## Re: 307 Fanshawe Rezoning Application Z-9006

The Old Stoneybrook Community Association would like to address questions asked by members of PEC at the meeting on May 27, 2019. Above all, PEC expressed a wish to know more precisely the community's thoughts regarding "number of units" of the project.

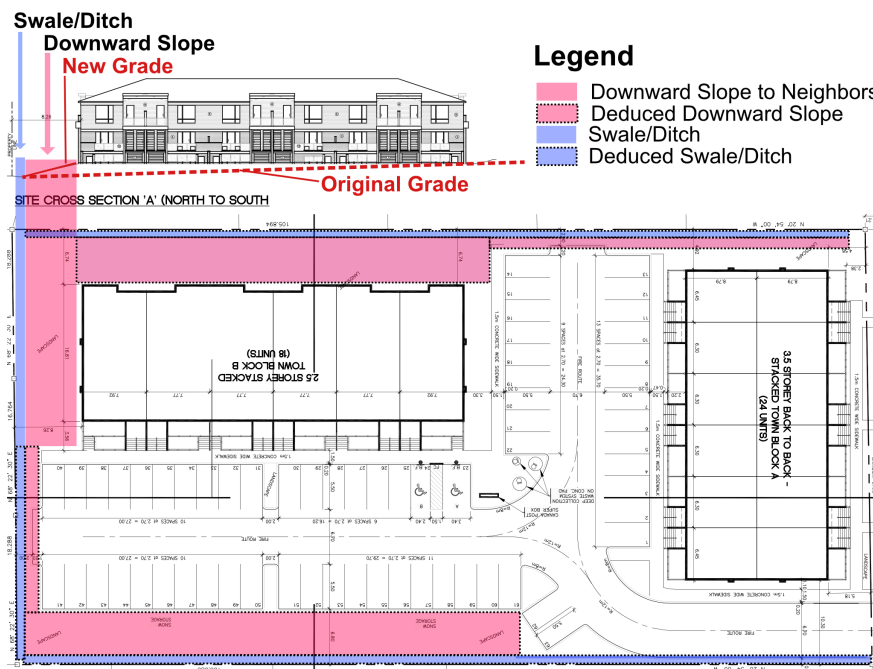
- b. **Wastewater Management and Privacy.** No comprehensive grading and elevation plan has been presented by the Developer. However, the elevation plans that they submitted for one of the buildings clearly indicate both a raised grade as well as a swale/ditch. The figure below shows the submitted plan and transposes the grade and ditch from the Developer's *Elevation* to their submitted *Site Plan*. We have indicated the consequences of what we interpret this will mean for the remaining borders of the Site plan: the site will be elevated relative to neighboring properties – water will drain to adjacent residences.
